BOARD OF APPEALS, CITY & COUNTY OF SAN FRANCISCO

Appeal No. **26-053**

Appeal of Building Permit 202608176686, issued 8/21/2026

280-282 Roosevelt Way, Block 2607 Lot 36

PLAN : ROOF
PERMIT SET

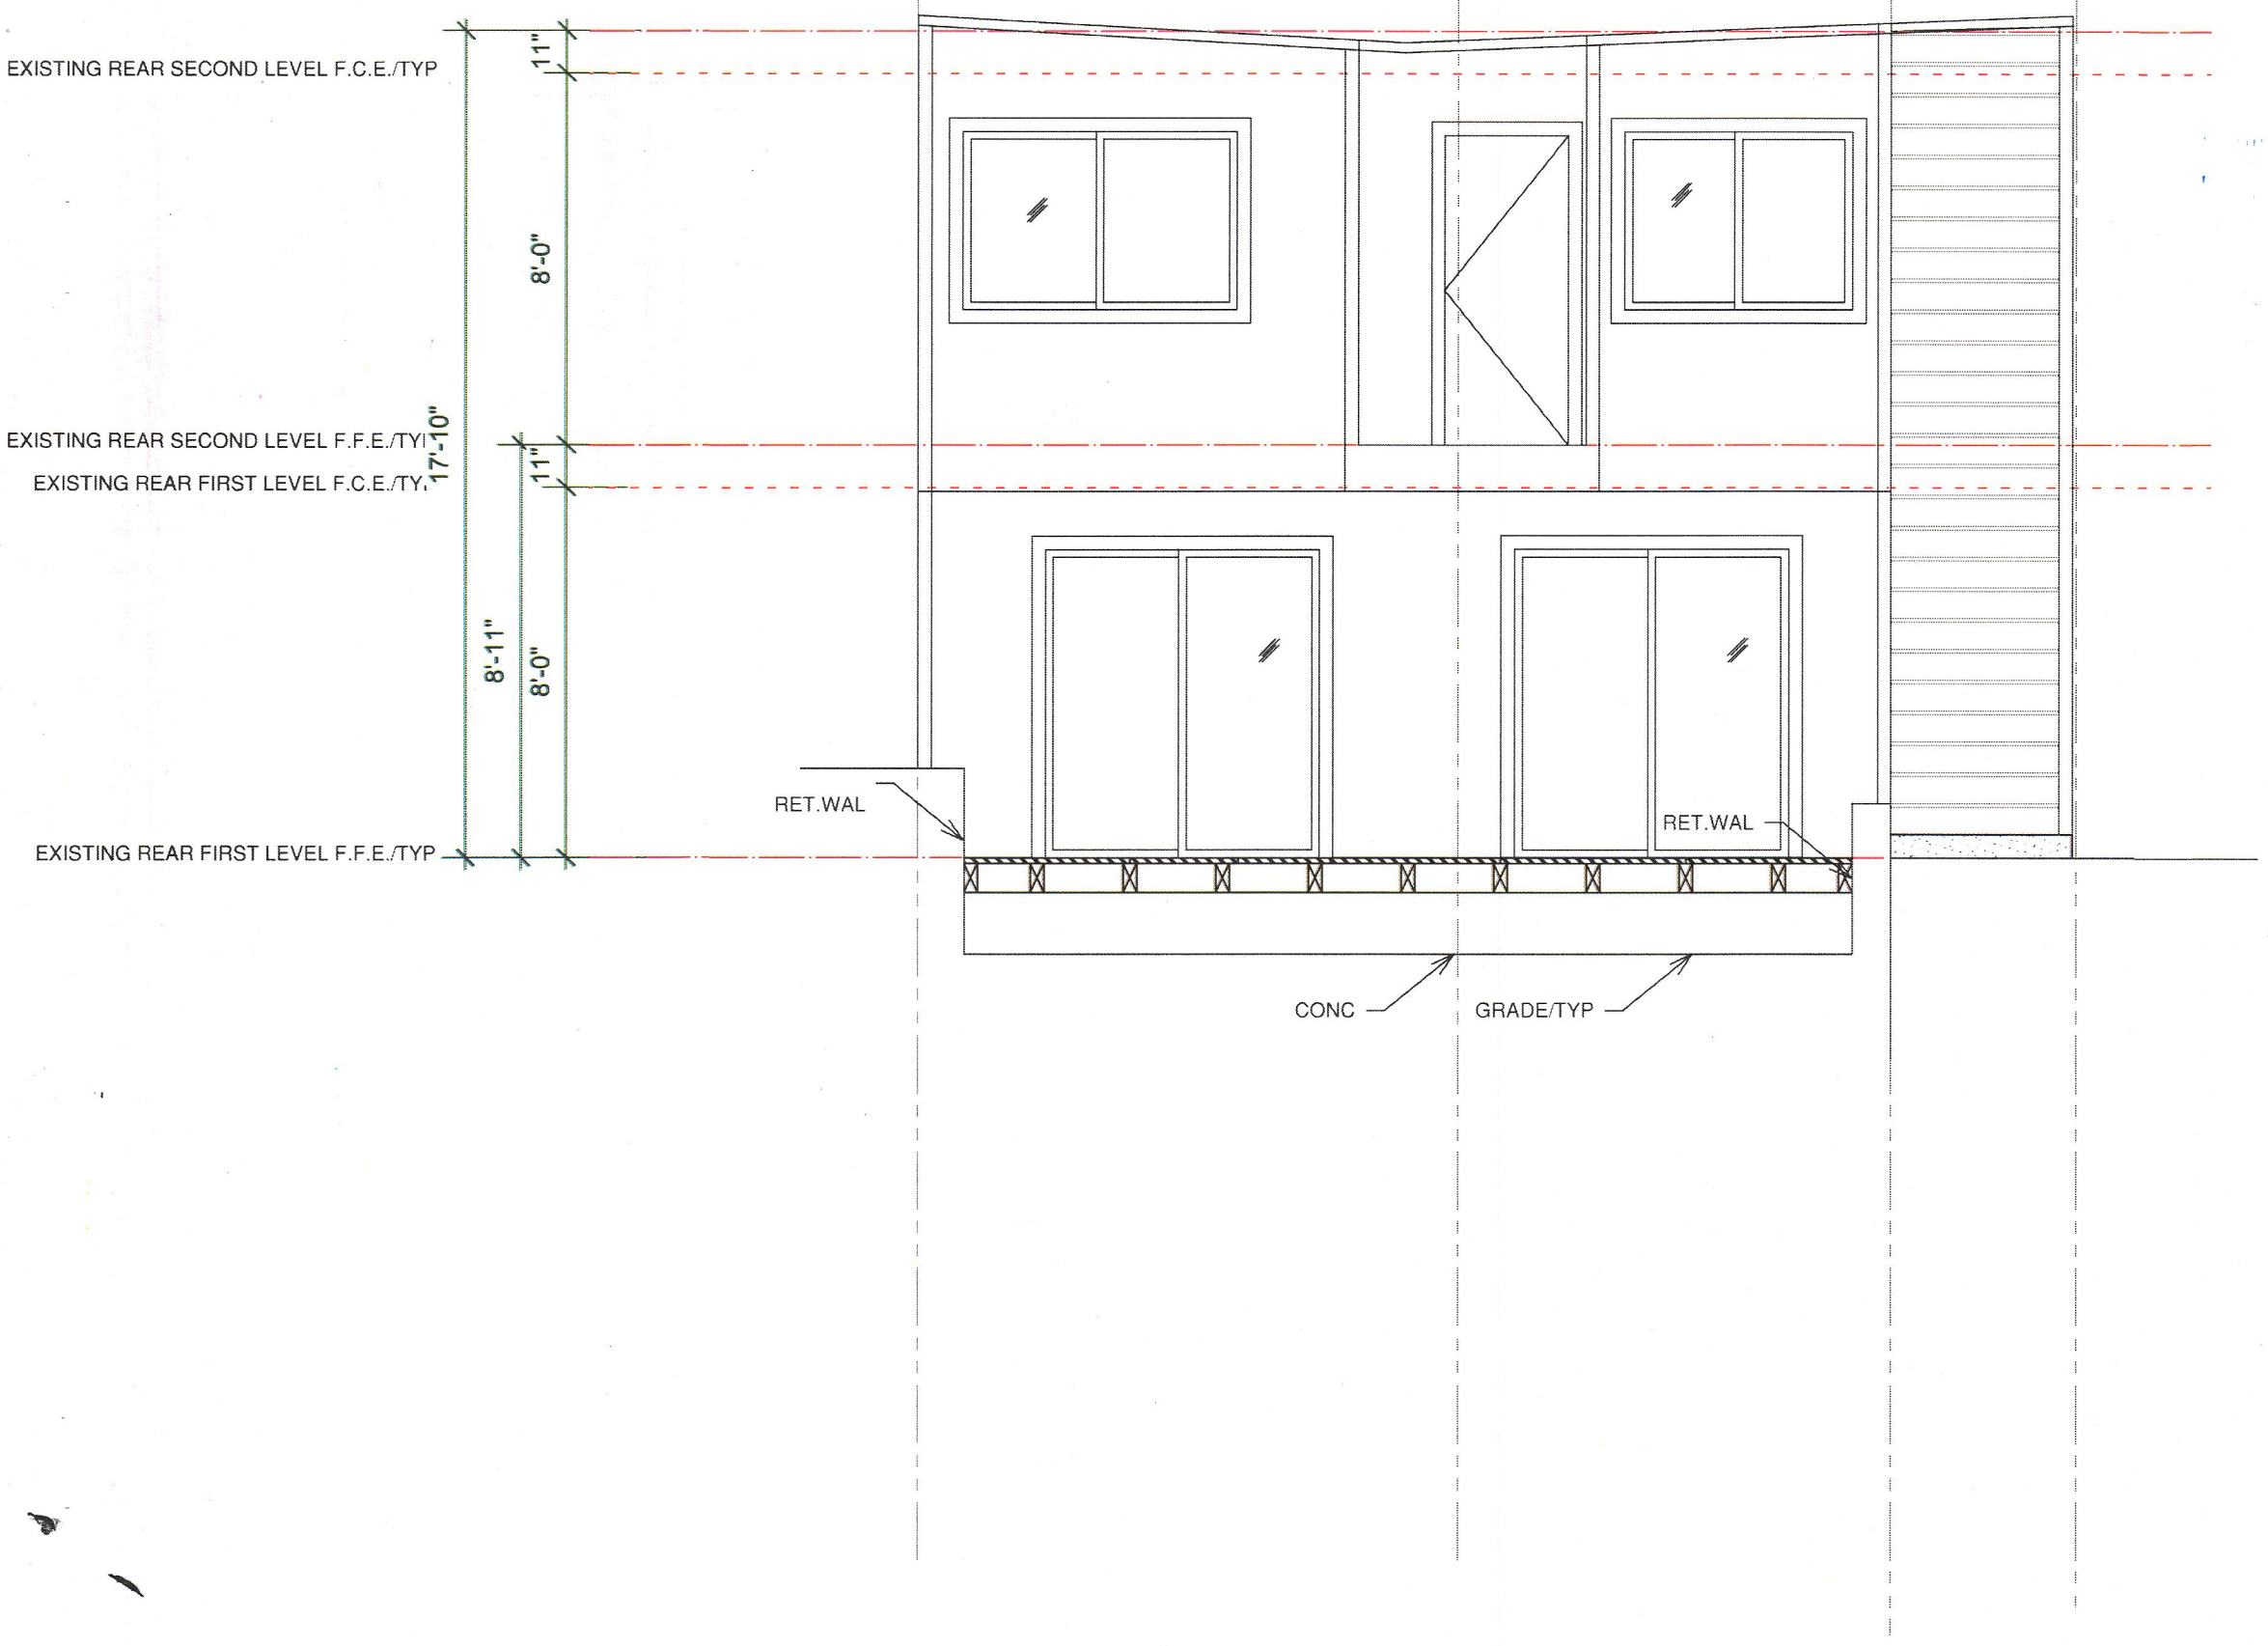
Before the firewall parapet was removed, I wrote the Project Sponsor with suggesting four ways he could eliminate the need for a firewall parapet in front of the skylight. I pointed out that he addressed a similar issue by eliminating a required parapet on the roof at the front facade. On Sheet A2.4, Detail 1/A2.3 Proposed Third Floor Plan, there

PROVIDE 30" PARAPET OR MOVE SKYLIGHT SO IT IS NOT WITHIN 60" OF PROPERTY LINE

The fire parapet at the skylight is 36" x 30" should be non-negotiable as the parapet is small, but protection of the skylight opening is critical.

3. The new parapet at the upper roof level adjacent to the existing skylight should not have been approved as the proposed parapet is located beyond the property line. The parapet should have been required to be set back to within the boundary of the subject property. It is unclear as to why this parapet was proposed to be installed, as the skylight shown in the existing roof plan, and as can be seen in Google Satellite View, is an existing non-conforming skylight. A new parapet is not required to be installed in this location. A parapet is only required when a new skylight opening is proposed to be installed in a roof and the skylight opening is located within 5'-0" of the interior face of a required fire rated exterior wall.
